CITY OF MERCER ISLAND

Pre-Application Meeting (PRE24-004)

The applicant proposes to develop a 3-story mixed-use building housing a K-8 private school on the lower levels and rental office space on the upper level and a half. The bulk of the project is situated on the B-zoned parcel at the northwest corner of the site. Parking, trash, utilities, and pedestrian paths are located on adjacent parcels owned by Herzl Ner-Tamid Conservative Congregation (HNT).

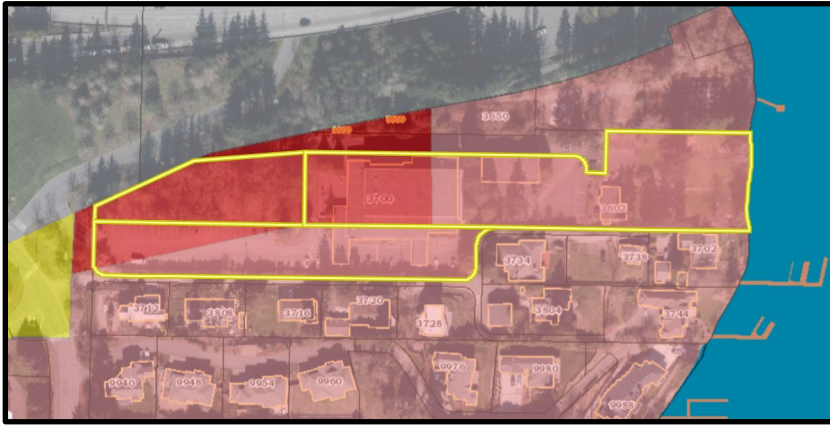
Pursuant to MICC 19.01.040(G)(2): Where a boundary between zones divides a lot into two or more pieces, the entire lot shall be deemed to be located in the first zone on the following list in which any part of the lot is located: R-15, R-12, R-9.6, R-8.4, MF-2L, MF-3, MF-2, PI, PBZ, C-O, TC, and B. The location of the zone boundary shall be determined by use of the scale appearing on the zone map unless the location of the boundary is indicated by dimensions.

Red is Zone B

Light Red: Zone R-9.6
